GENERAL

This addendum forms a part of the Contract Documents and modifies the original Bidding Documents dated April 2024, and consists of pages AD1-1 through AD1-3 Specifications Sections listed below, and Drawings Sheet listed below. The following changes, additions and/or deletions shall be made to the following documents: all other conditions shall remain the same.

SUBJECT: Narrative of changes for **Post Approval Document NO. 001**
 HGA Commission Number 1500-148-00
 UCDH Gen. Radiology Equipment Replacement - Rooms 1P752, 1P754, & 1P758
 HCAI #: **S231373-34-00-ACD-001**

M055565
SESP 1P752, 1P754 &
1P758 ED X-RAY
REPLACEMENT

POWER PLAN - LEVEL 01

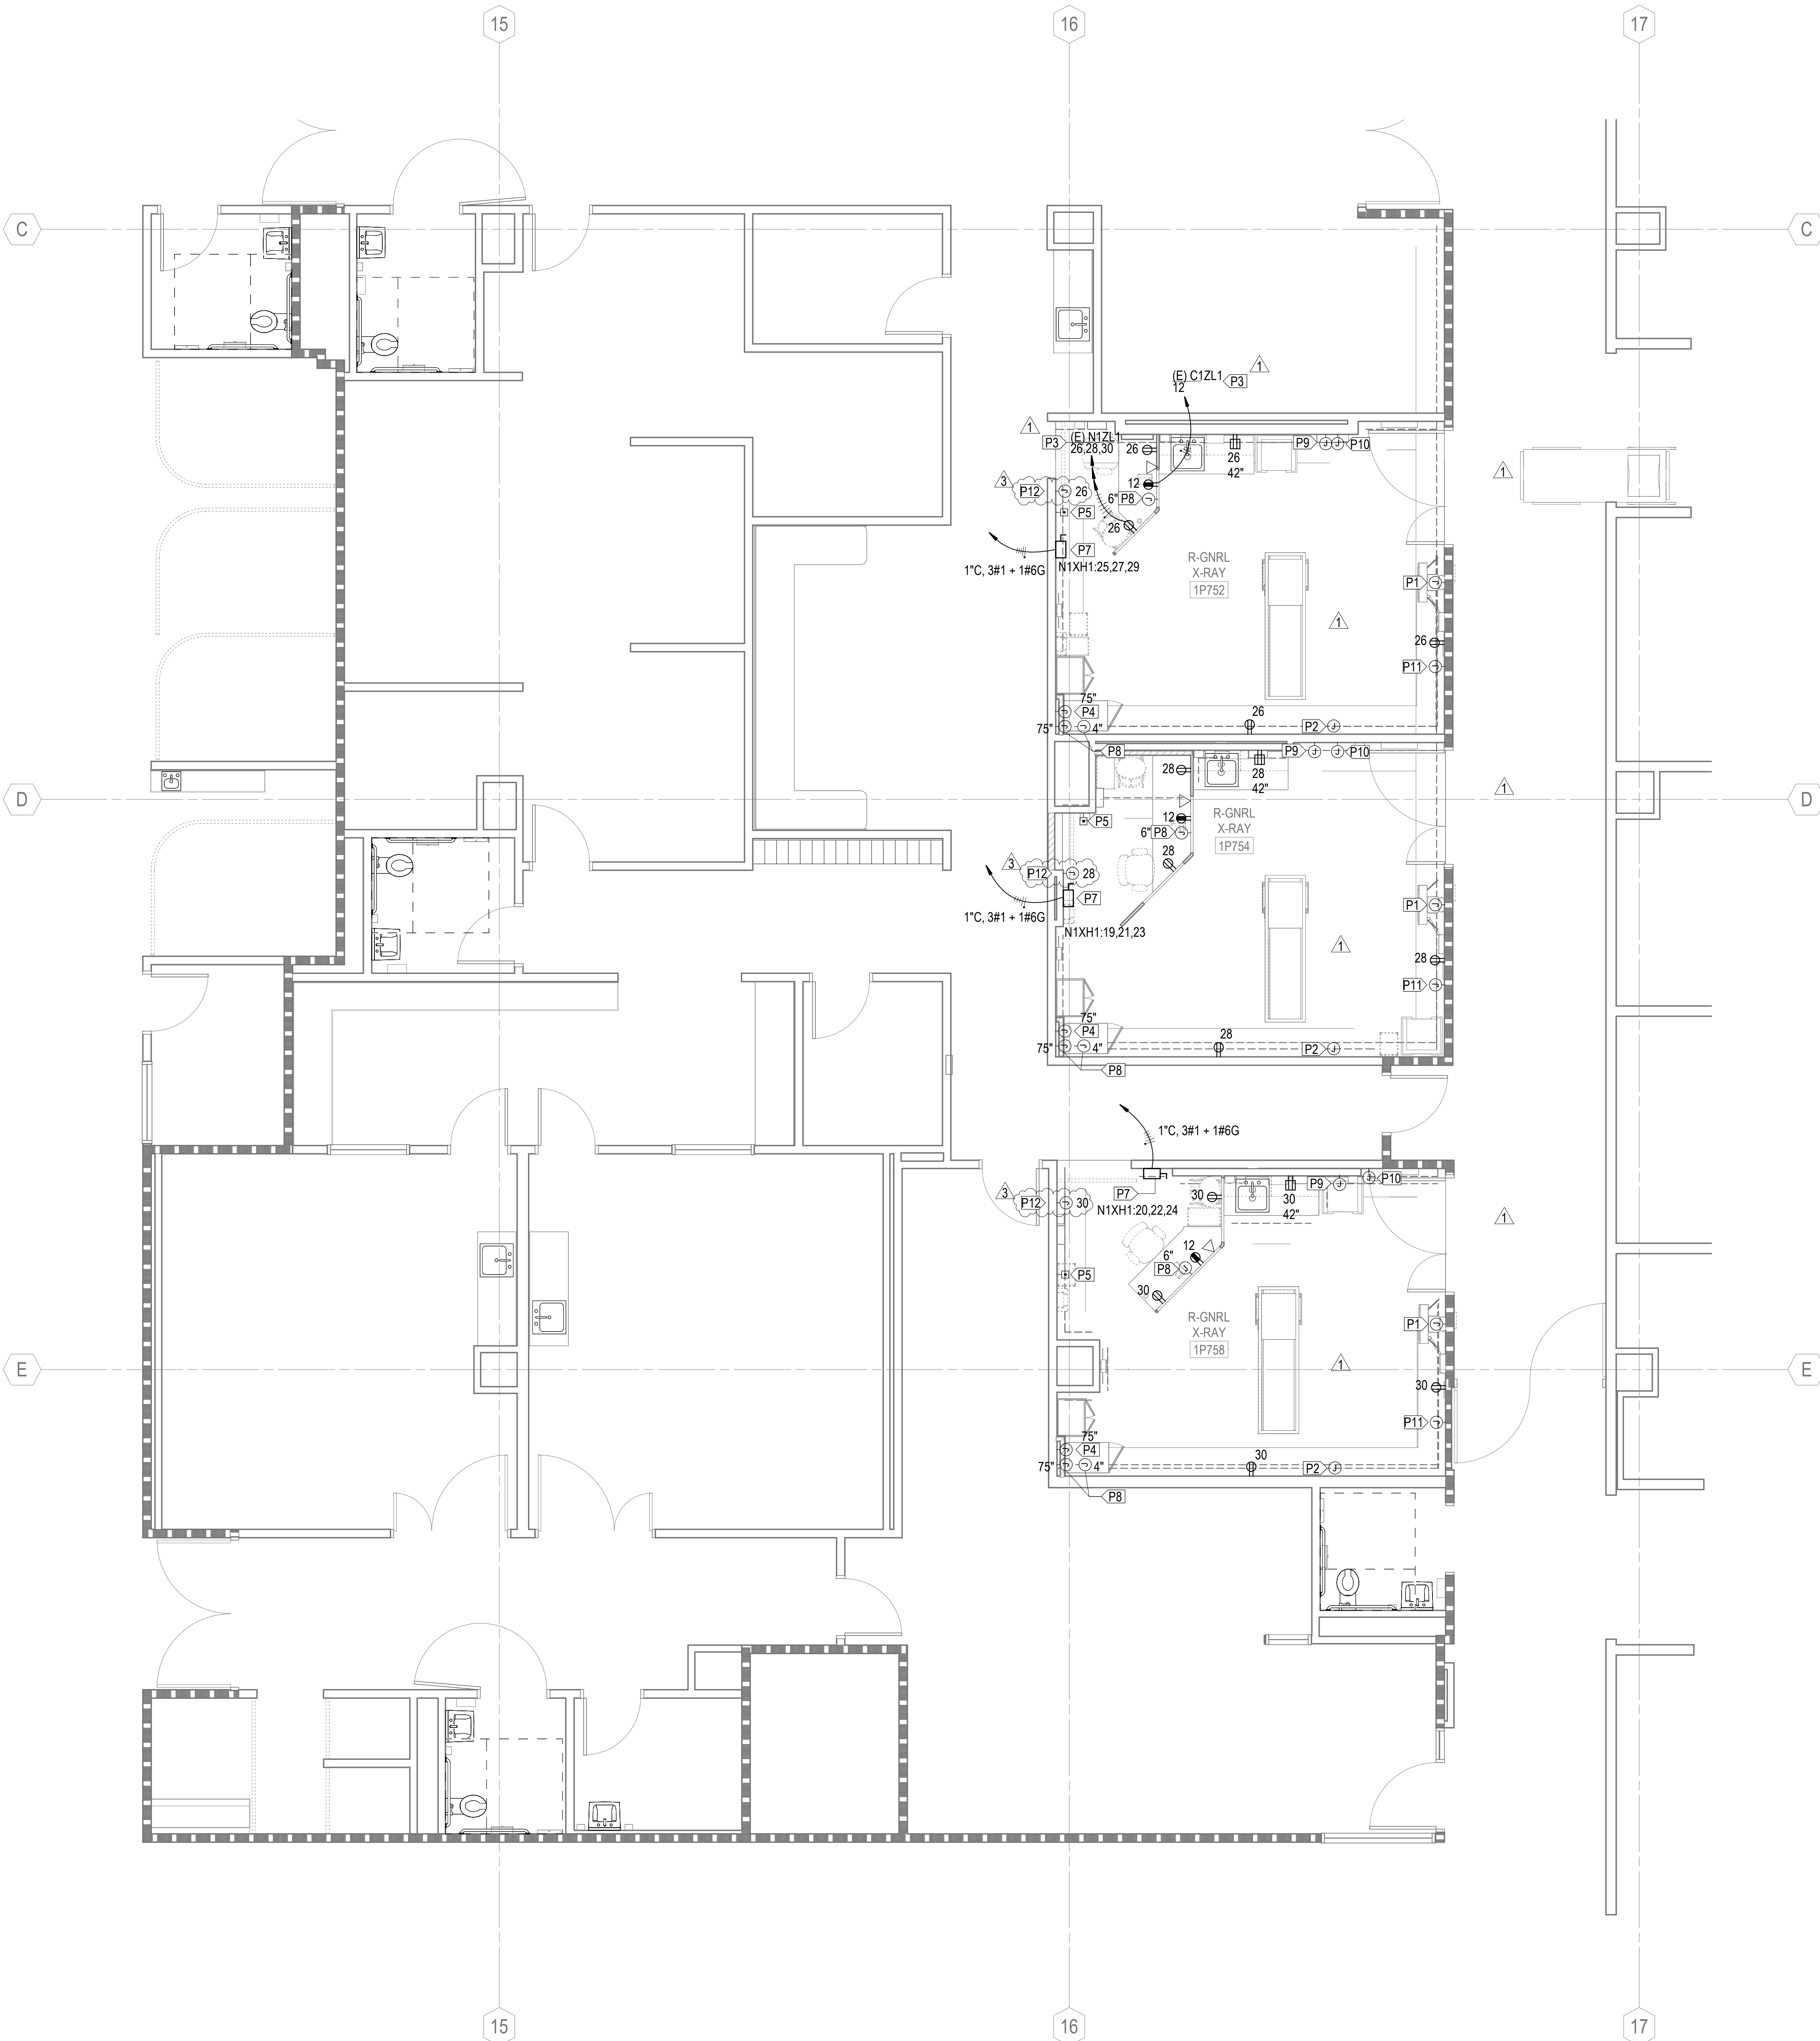
Q7: Please confirm if the use of the University electrical system for temp power is available per Section 01 51 00.

A7: Use of University electrical system for temporary power is available. DPOR will provide an ACD to identify the allowable non-emergency circuit to utilize inside each room for temporary power.
